Re: Response to Notice of Violation, dated April 5, 2023  
In the Matter of Brent Run Landfill, Montrose, Michigan

**Response to Notice of Violation, 04-05-2023**  
**EGLE – Air Quality Division**

**VIOLATION NOTICE**

**GCCS 2021 CONSTRUCTION  
 GCCS 2021 RECORD PLAN**

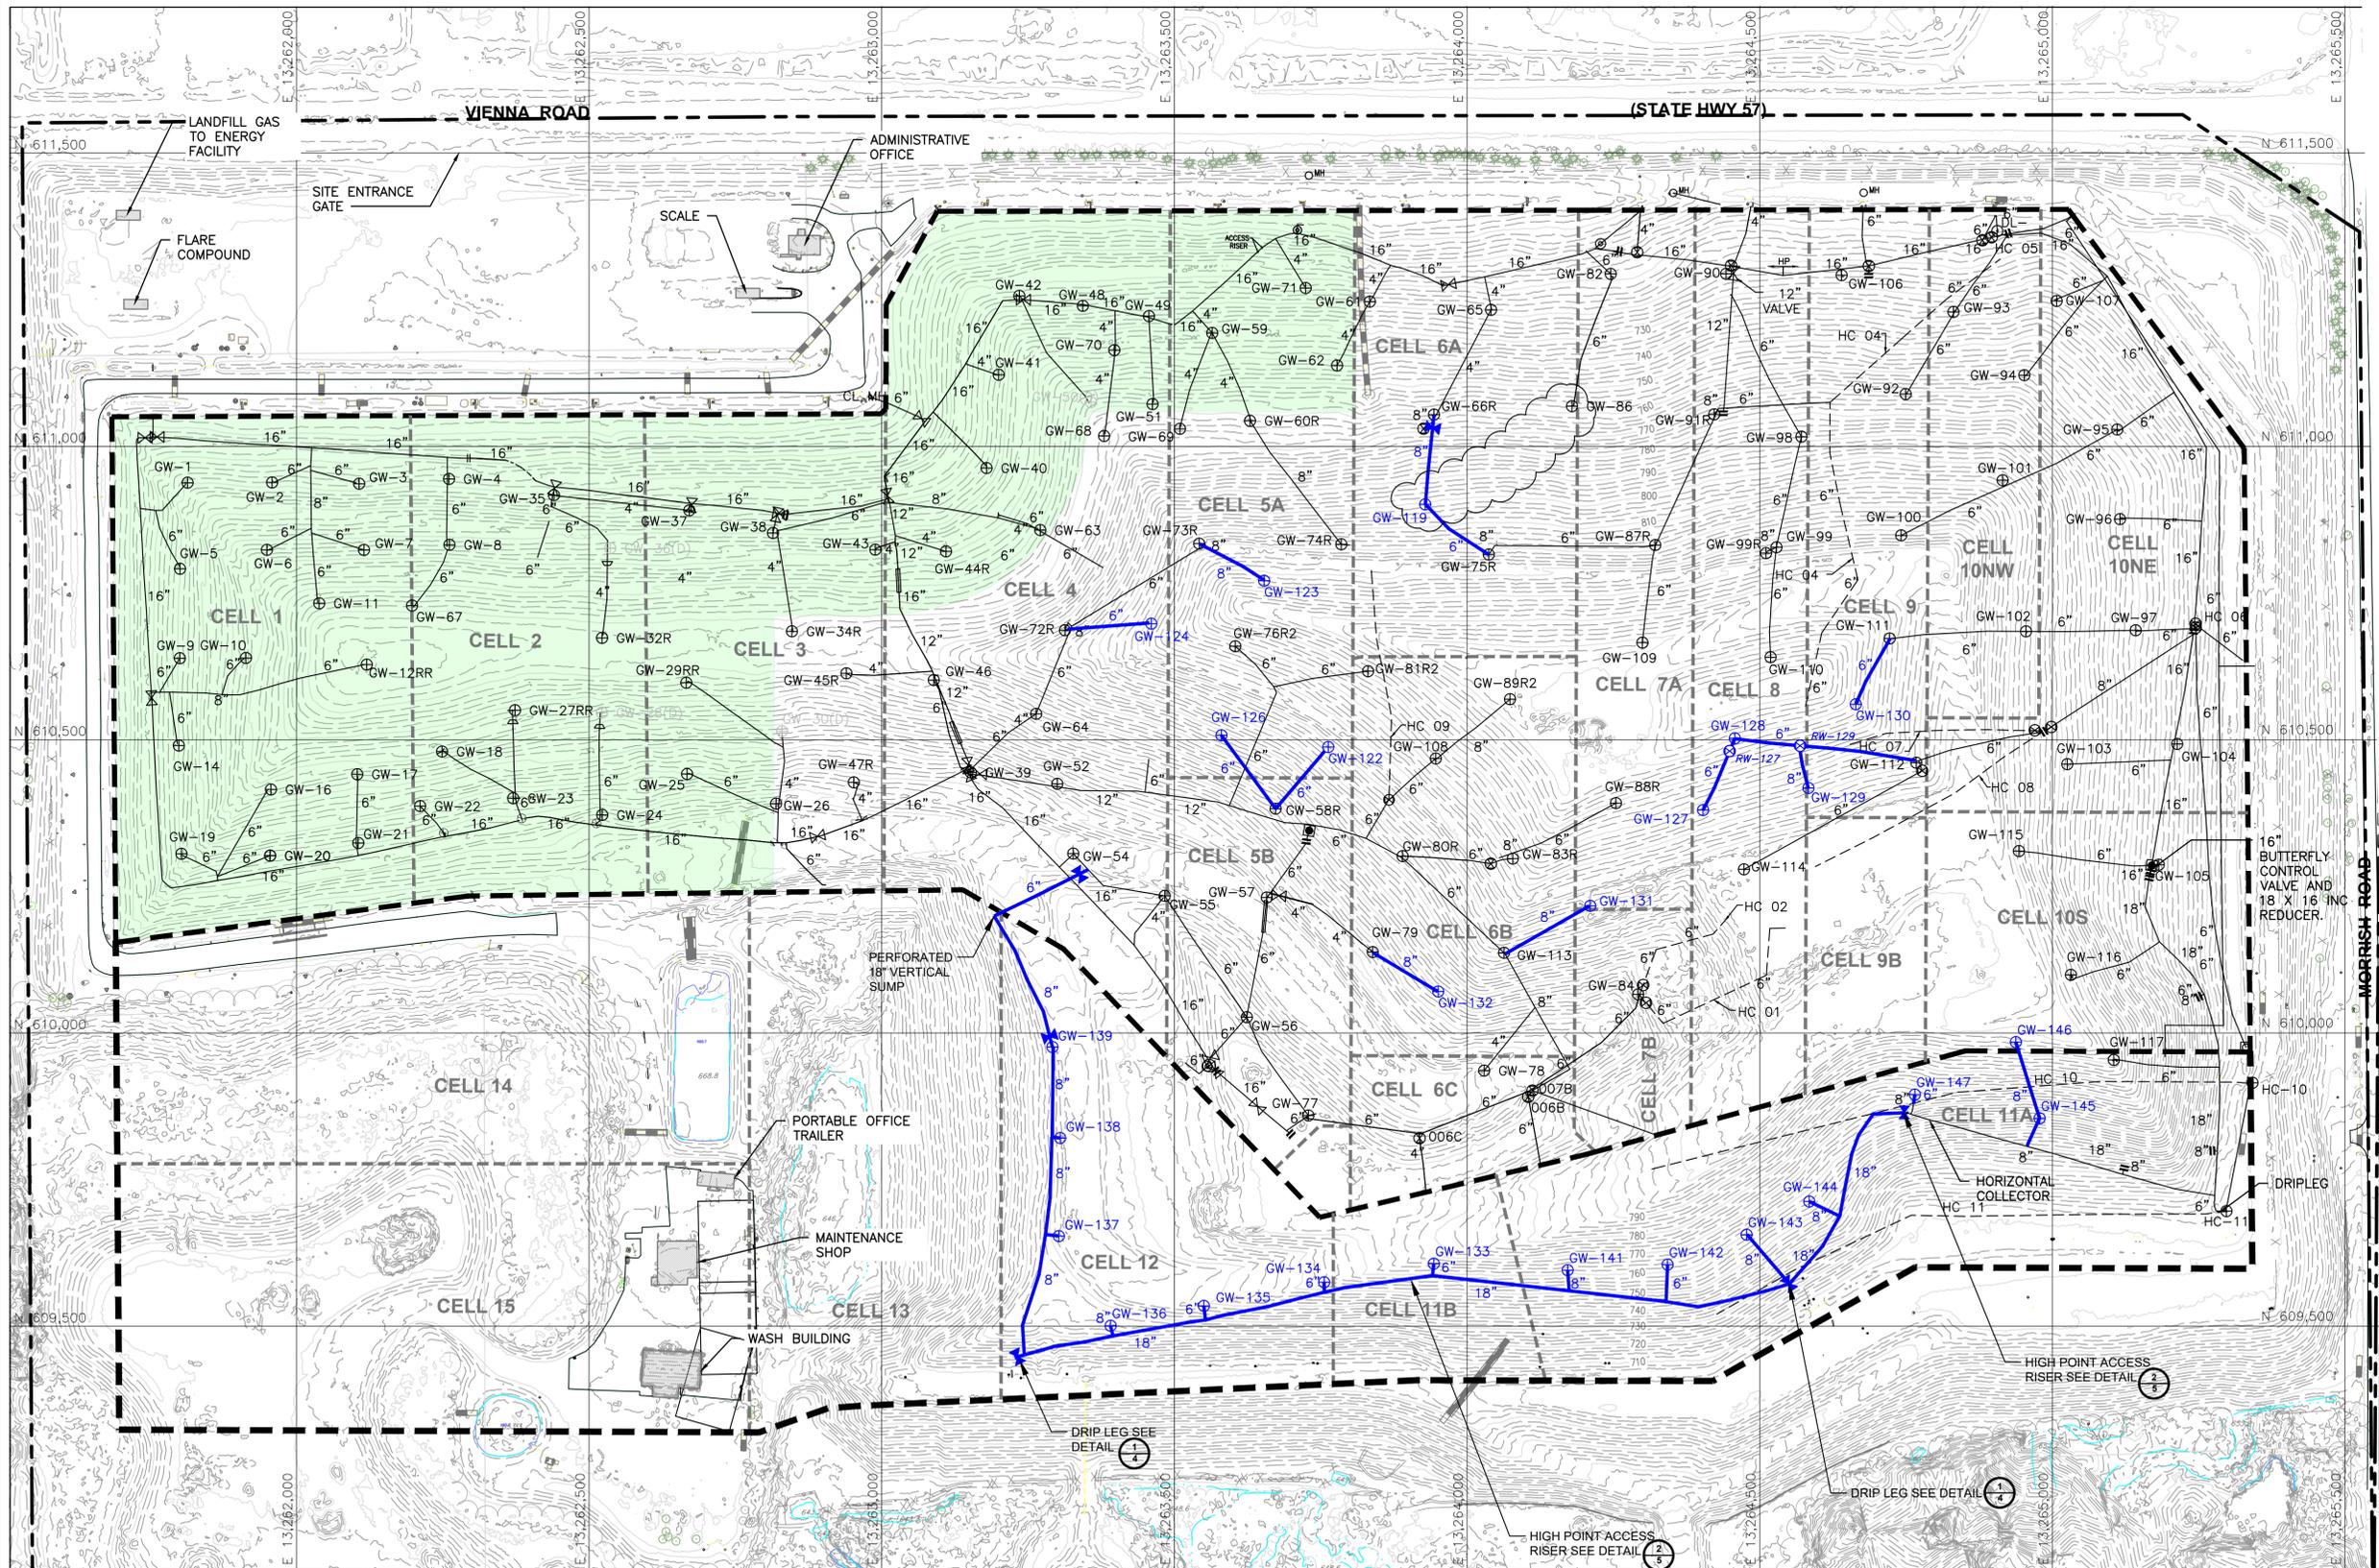
Waste was first placed in the expansion area on November 1, 2016. Cells 11 and 12 currently contain waste and an active GCCS, while Cells 14-15 do not contain waste (See Attachment 2). An active GCCS was first required in Cell 11A (eastern part of Cell 11) as of October 31, 2021, when the waste placed reached five years of age. Brent Run installed the GCCS in Cell 11A in May 2018, more than three (3) years earlier than required under the regulations.

Based on a comparison of the 2004 GCCS design plan and the 2021 GCCS construction map, it does not appear that Cells 11A, 11B, 12, 13, and 15 were included in the approved 2004 GCCS design plan.

Additionally, comparing the 2004 GCCS design plan with the 2021 GCCS construction map, the well placement and density of wells in Cells 4, 5A, 5B, 6A, 6B, 6C, 7A, 7B, 8, 9, 10 NE, 10 NW, and 10S are greater than, and in most cases located at positions within the landfill

that are markedly different than, the well placement and density of wells in the 2004 GCCS design plan.

By failing to submit a revised design plan for areas where waste-placement operations have expanded that are not covered by the previously approved design plan, and for failure to submit a revised design plan to ensure that all well placement is conducted according to a professional engineer-approved design plan, BRL is in violation of 40 CFR 63.1981(e)(1) and 40 CFR 63.1981(e)(2).

The NOV requests submittal of a revised GCCS design plan to resolve the alleged violations. **Brent Run will submit an updated GCCS design plan covering all expansion areas within 60 days of this response letter.** Brent Run is interested in continuing to work with the Department to resolve all alleged violations. If you have any
